APPLICATION NUMBER

5616

A REQUEST FOR

BOARD OF ZONING ADJUSTMENT

SITE PLAN

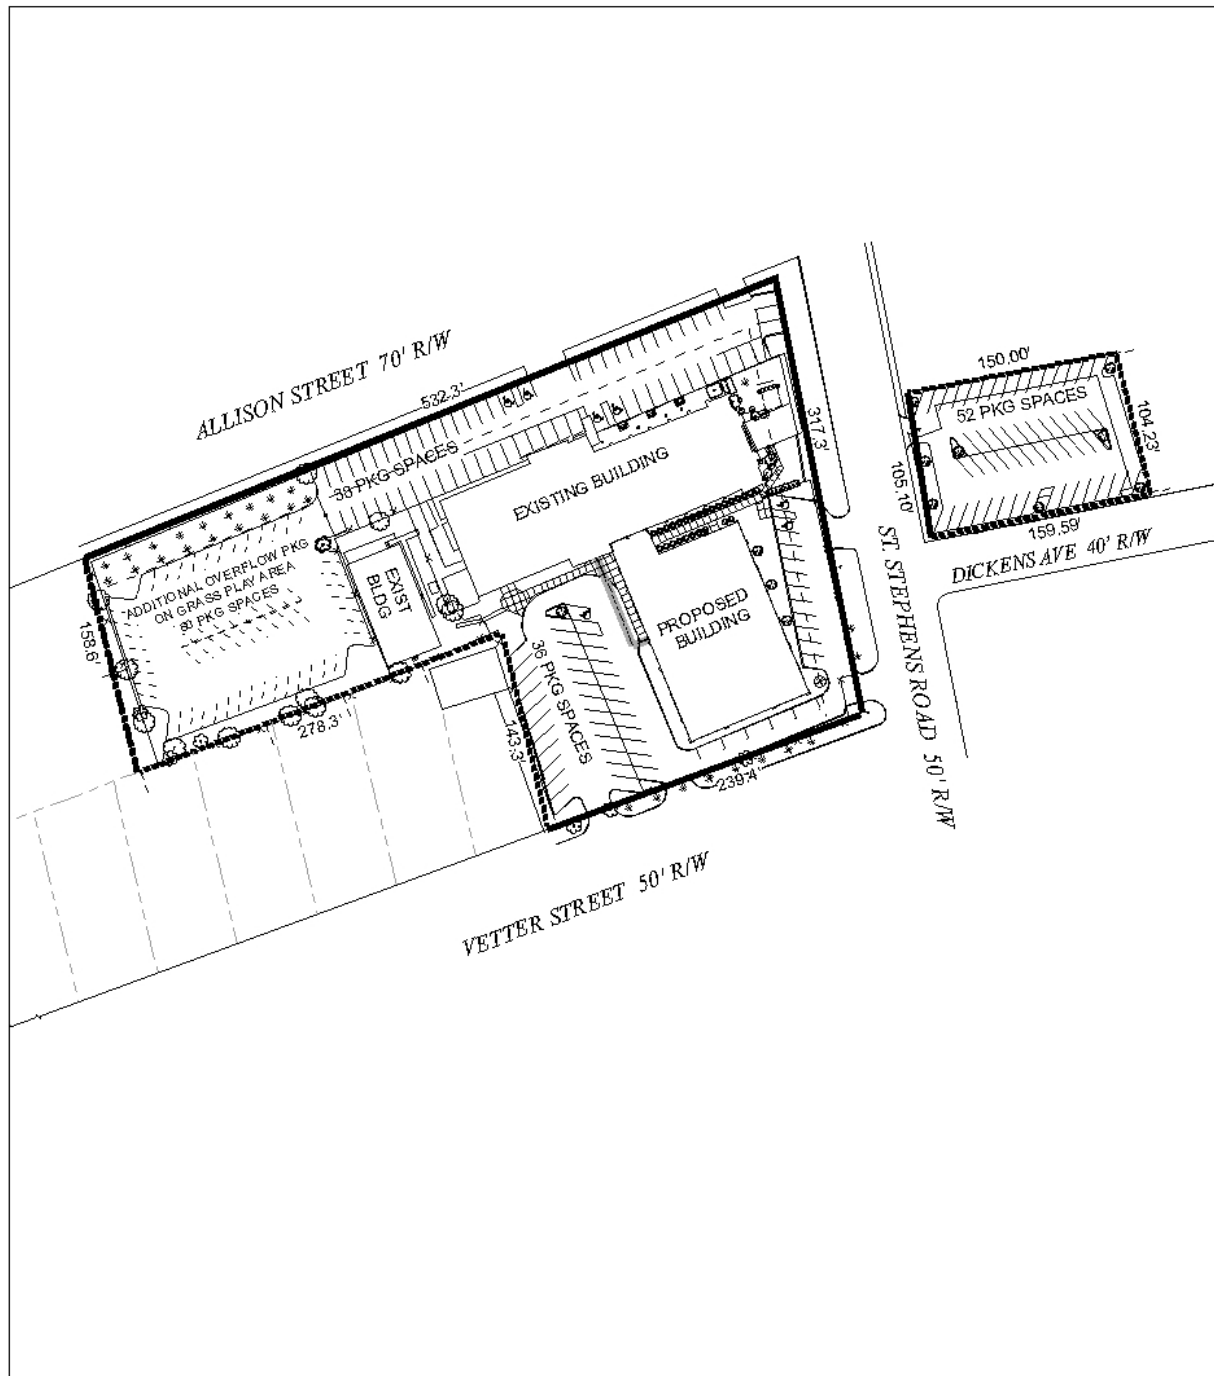
To relieve the reduction in the on-site parking which would be caused by the location of the multi-purpose building, the applicant proposes to utilize an existing grass playground area at the West end of the existing paved parking area along the South side of Allison Street as an overflow area and proposes to expand the existing paved parking area across St. Stephens Road. However, the site plan indicates that both areas would serve to suffice the minimum required parking spaces and the grass parking would not be a true overflow parking area. By the occupancy table provided, 229 parking spaces are required, and the site plan indicates 230 total parking spaces proposed, only one more than required.

Traffic Engineering has conducted a review of the proposed parking plan for the main site and has concluded that two of the existing parking spaces at the entrance to the proposed grass parking area would be unusable, and two of the proposed parking spaces on the grass at the entrance would be unusable due to access restriction, and the two Eastern-most grass parking spaces in the center rows would be unusable due to access/maneuvering issues. Also, the five proposed parallel parking spaces at the South end of the proposed building do not meet the length requirements for parallel parking and the drive aisle space beside them is only approximately 10'. The proposed new entrance on St. Stephens Road just North of Vetter Street will not be approved by Traffic Engineering due to its proximity to the corner. With the eleven parking spaces not approved by Traffic Engineering, the required parking would be short by nine spaces, considering the one extra space indicated on the site plan.

The landscaping plan submitted for the off-site parking area indicates only under-story trees proposed. In similar cases, off-site parking areas have been required to provide full compliance with the landscaping and tree planting requirements of the Zoning Ordinance. As this is a corner site, over-story trees would be required along both St. Stephens Road and Dickens Avenue and sufficient area does not appear to be provided for such. There are no landscaping/tree planting calculations furnished for the off-site parking area.

The applicant failed to illustrate that a literal enforcement of the Ordinance would result in an unnecessary hardship with respect to providing paved parking and it appears that the proposed church expansion may over-build the site with respect to its vehicle parking and maneuvering capabilities. Even if the grass parking were allowed, substantial modifications to the site plan would be required to satisfy Traffic Engineering concerns on the main site.

Regarding the off-site parking area, located across St. Stephens Road (a proposed major street) from the site, it is staff's opinion that the site would be over-developed in that there would be substandard allowances for landscaping and tree planting ratios. Furthermore, staff would not want to encourage additional pedestrian traffic across a major street such as St. Stephens Road, without appropriate pedestrian facilities such as sidewalks and crosswalks.

Based on the preceding, this application is recommended for denial.
